Strathfield Local Planning Panel Meeting

Thursday, 4 February 2021

TO: Strathfield Local Planning Panel Meeting - 4 February 2021
REPORT: SLPP – Report No. 1
SUBJECT: DA2020/149 - 3 GEES AVENUE, STRATHFIELD - LOT 2 DP 7904
DA NO. DA2020/149

Figure 13. Front elevation of the proposed dwelling house (source: N Lyckeno Architect, dated May 2020)

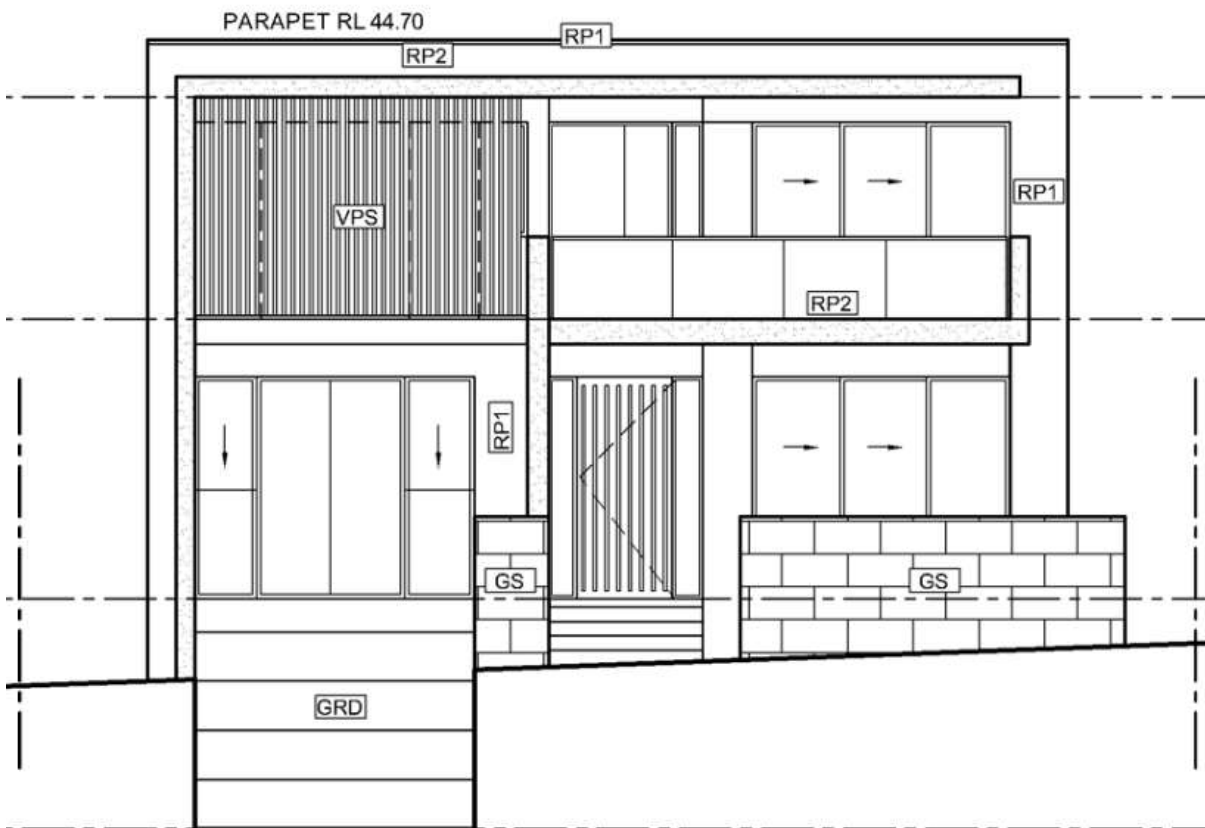
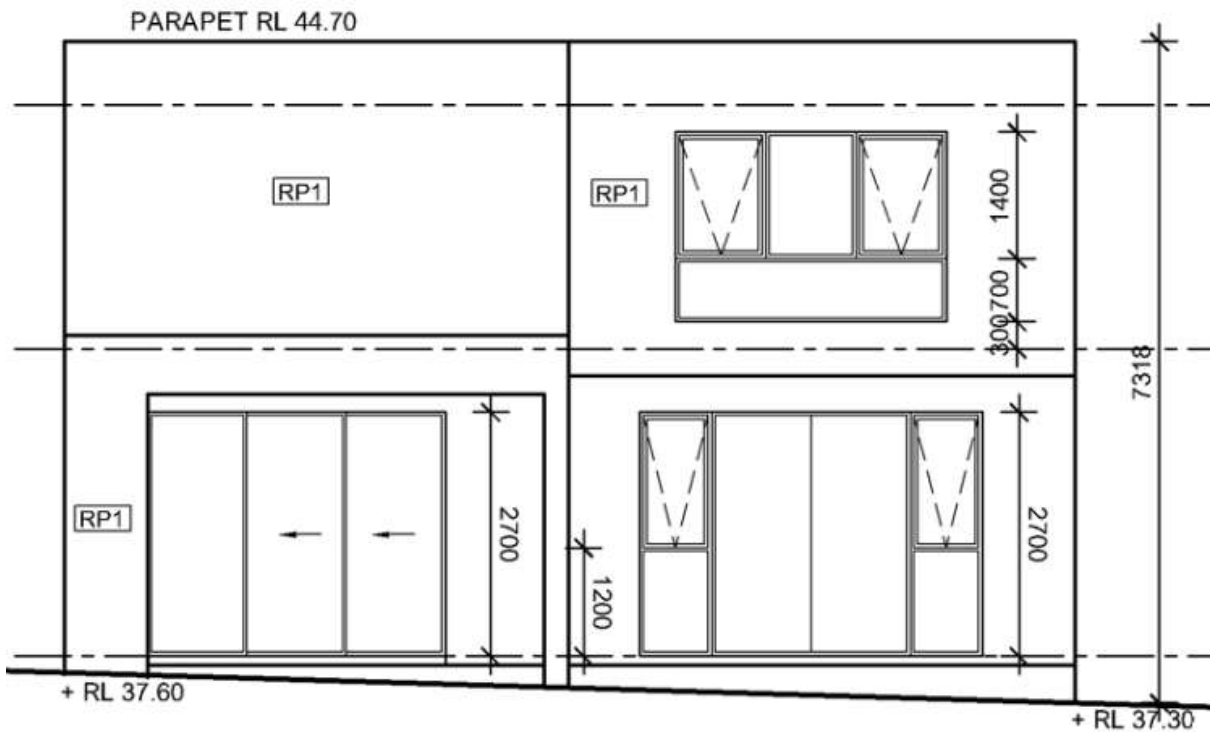
The proposed dwelling house has a design that is not consistent with the established streetscape character. In particular, the proposal includes a flat roof form when viewed from Gees Avenue, while the neighbouring properties all have pitched roofs. A dwelling house that was constructed in January 2020 at 4 Gees Avenue, seen in Figure 12, has a pitched roof design that integrates well with the rest of the development along the street.

The provided SEE and response letter to Council dated 6 November 2020 both indicate that there is an absence of any established pitched roof rhythm in the area. This reasoning is considered incorrect. As shown in Figures 7, 12, 13, 14 and 15, the immediate locality has an established pitched roof form character.

Figure 17. Extract of the recent set of plans of the proposed basement (source: N Lycenko Architect, received 09/11/2020)

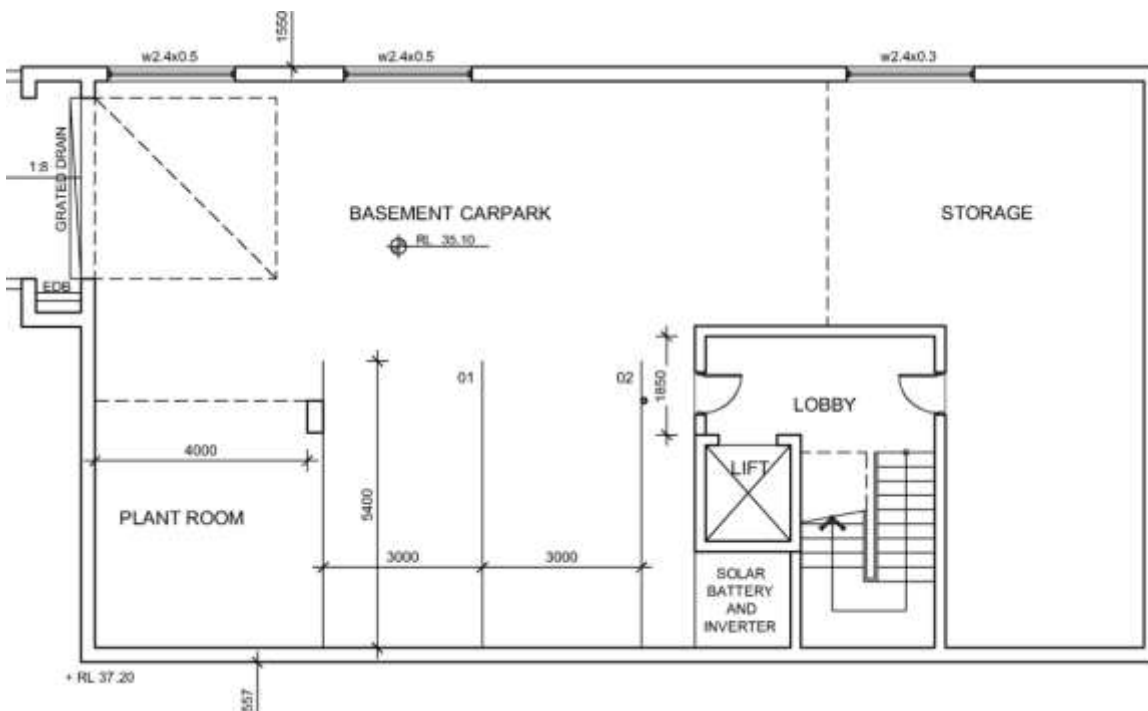
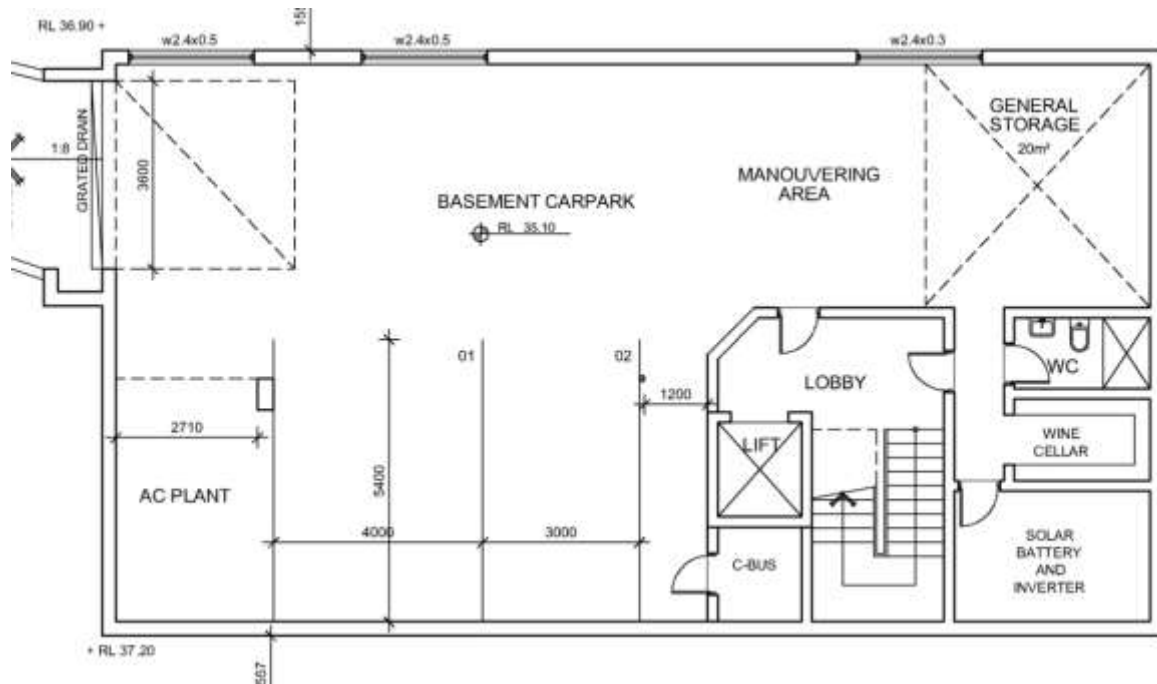
The initially submitted proposed basement and the most recent layout are shown in Figures 16 and 17 below. The initial design has an unreasonable storage area size at the rear of the basement and a solar battery and inverter area that has not been included in the plant room. This design, as communicated with the applicant by way of additional information letter sent on 14 October 2020, was deemed unsupportable due the unreasonable size of the basement.

The letter sent to the applicant raised the concern of the proposed basement in Figure 16 exceeding the floor space ratio permitted by the SLEP 2012. The applicant has responded by amending the layout of the basement and has incorporated more plant rooms, a wine cellar and a water closet. The footprint of the excessive basement has not changed with new partitions presenting as toilet, wine cellar and solar battery and inverter room. The most recent basement design is still considered excessive; hence, is it not supportable.

Figure 18. Extract of the east elevation of the proposed dwelling house (source: N Lycenko Architect, dated May 2020)

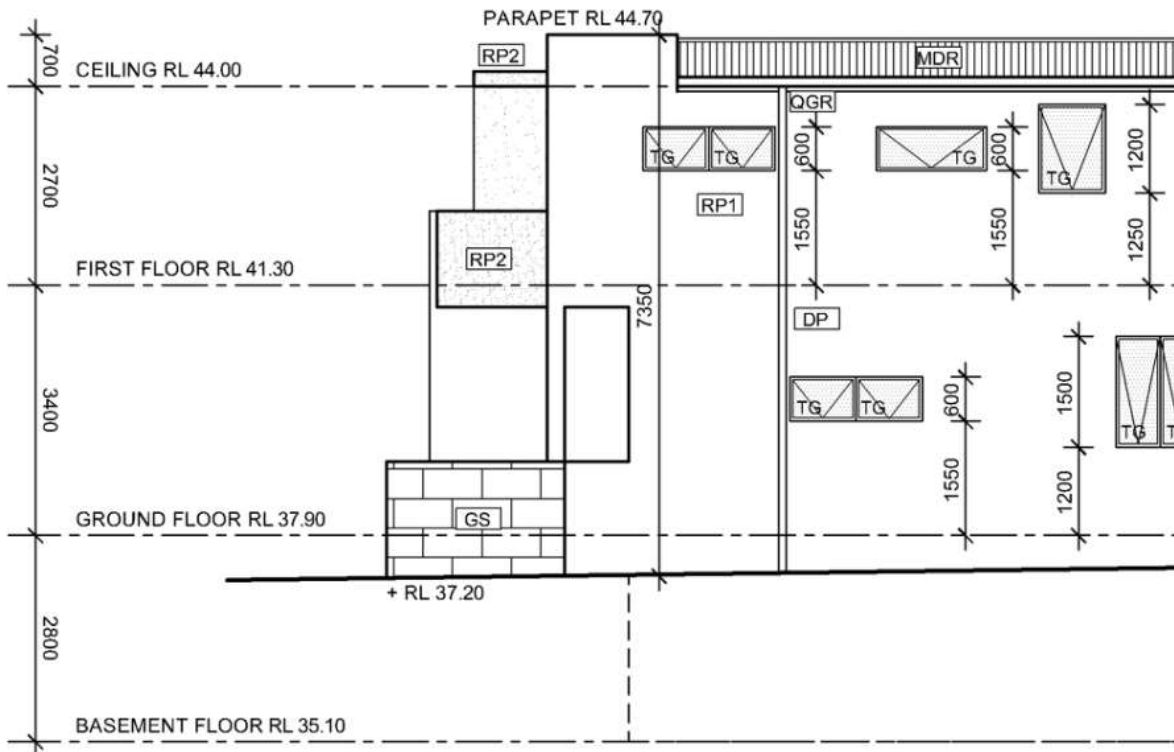
The submitted elevations failed to clearly demonstrate the ceiling height of the ground and the first levels of the proposed dwelling house. To clarify, as an example, Figure 18 below shows that the floor levels of the grounds and first floors are separated by 3.4m. It does not clearly specify the height of the ceiling.
